SERVICE BULLETIN

B-066

Safety Recall Code 0833

2006-2007 ULYSSES XB12X BANK ANGLE SENSOR RECALL

Figure 1. Bank Angle Sensor (current location)

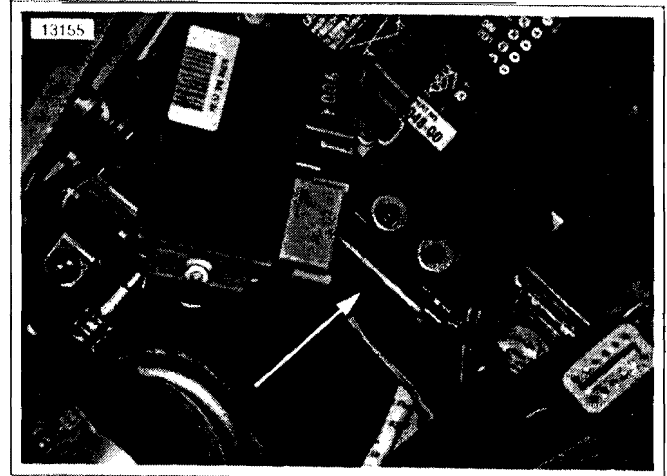
2. Disconnect negative battery cable
3. See Figure 1. Remove screws and washers to detach BAS.
4. Unplug bank angle sensor connector and remove BAS.

Figure 2. Bank Angle Sensor Bracket (Mounting bracket turned upside down for clarity)

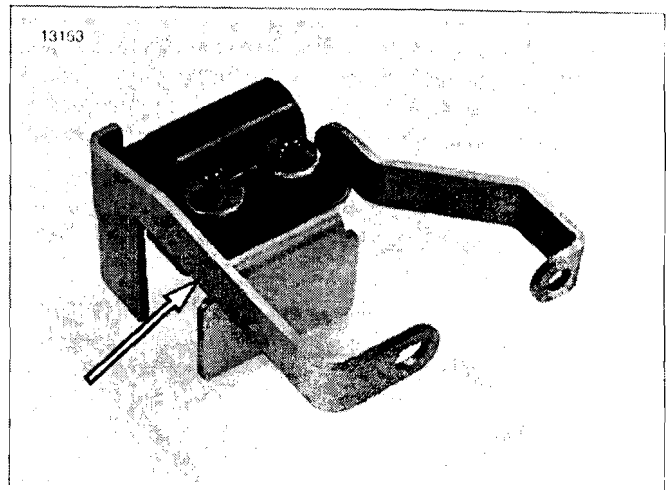
1. See Figure 2. Install bank angle sensor to the underside of the mounting bracket with original fasteners. Tighten fasteners to 12-36 in-lbs (1.4-4.1 Nm).
2. Connect harness extension cord to main harness connector [134].
3. See Figure 4. Route the harness extension cord under the ECM and along the right tail section to the tail loop.
4. Route the harness extension cord below the rear auxiliary power outlet and behind the seat latch bracket.
5. Connect harness extension cord to BAS.
6. See Figure 4. Install the BAS mounting bracket to seat latch bracket using the original seat latch fasteners. Tighten the fasteners to 60-96 in-lbs (6.7-11 Nm).
7. See Figure 3. Using the wire retaining clips with self adhesive backing, attach the harness extension cord to the right tail section.
8. Connect negative battery cable. Tighten fastener to 72-96 in-lbs (8-11 Nm).
